**Reviewer 1:**

**Comments to the authors**

*The manuscript describes the methods and analytical techniques including adjustments and correction applied to seawater stable isotope data ( $d_{18}O$ ,  $d_2H$ ) in the LOCEAN data base, which hold more than 20 years of measurements from various cruises. The authors discuss the different sources of error and uncertainty. Overall, for  $d_2H$  the authors are bit too optimistic for the precision of the data. Especially IRMS measurements in the past have not reached the precision of the latest CRDS generation. So, the claimed standard deviation of 0.15 (line 8) is most probably far too optimistic. The data set itself is of high value for various research disciplines and the authors did their best to describe the quality and limitations of the data. I made some more specific comments to some sections below. Technically, the manuscript is adequately organized and language does not need any revision. With some minor revisions, the manuscript should be publishable in ESSD.*

Example of changed labels on figure 3 (with two columns A and b), and alternative proposition for figure 3.

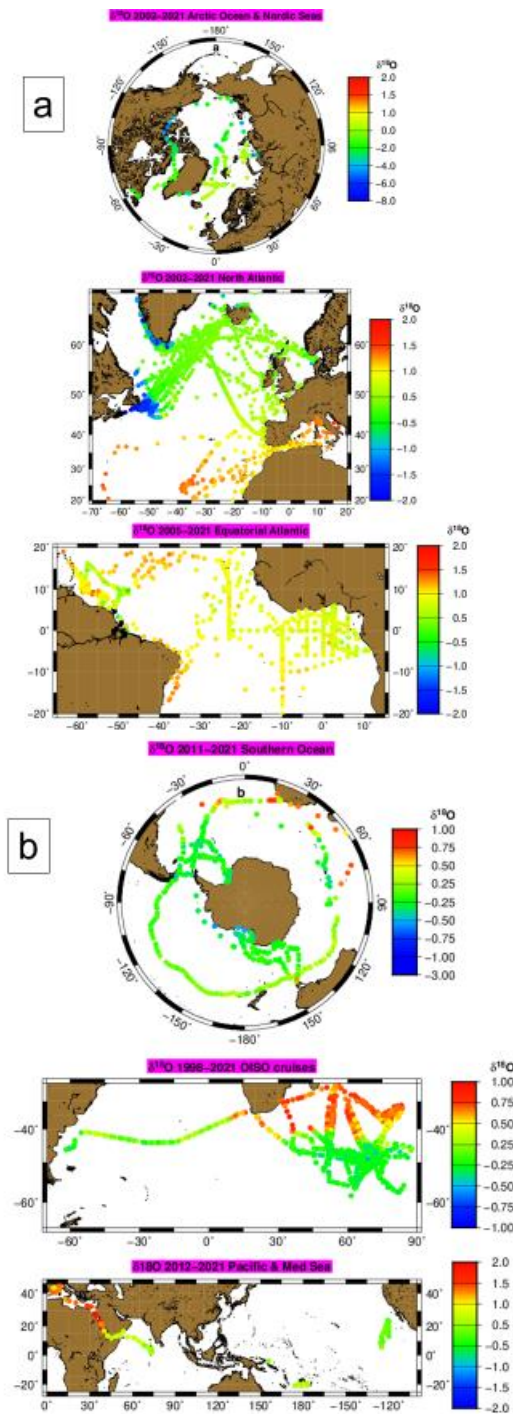
*Figure 3: add labels to each panel. Also you do not need to say “six maps”. Readers can see the number of maps. Just label them and caption each label separately. Also add axis label to the color bars.*

An alternative version for figure 3 would be to just have one panel (the whole world) with a slightly different colour scale, which we attach for your appreciation (of course, we would add a title and the variable name  $\delta^{18}\text{O}$  on the color bar). Our current preference is to stick with the first option with six panels in two columns.
